Product change information (PCN)

| PCN No.: | AAA170098 | Date: | 21.11.2017 |
| Product: | GMKDS 3 | | |

| Previous production status | New production status |

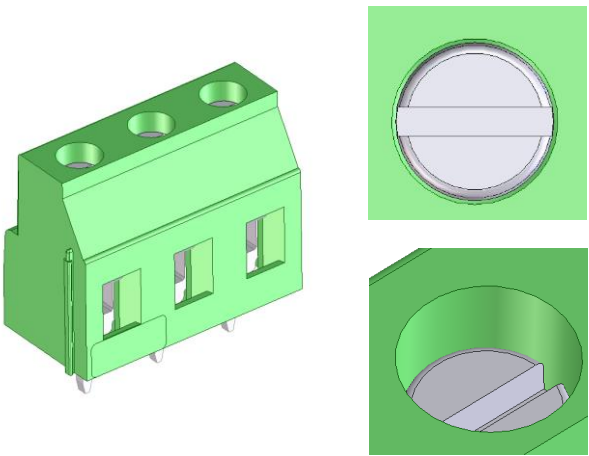
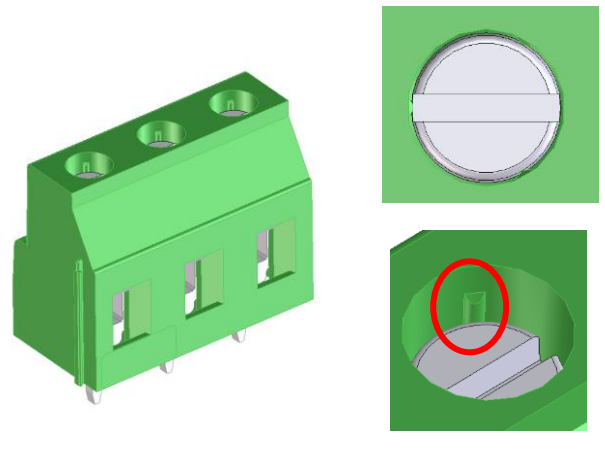
| Introduction of a screw brake |
| <p>Within the scope of continuous improvement, the aforementioned product family will now include a screw brake. This will prevent the closing of clamping spaces during transport. For implementation, we are adding three plastic ribs to the screw shaft. The technical data remain unchanged. During the transition phase, both versions will be delivered simultaneously depending on inventory.</p> |
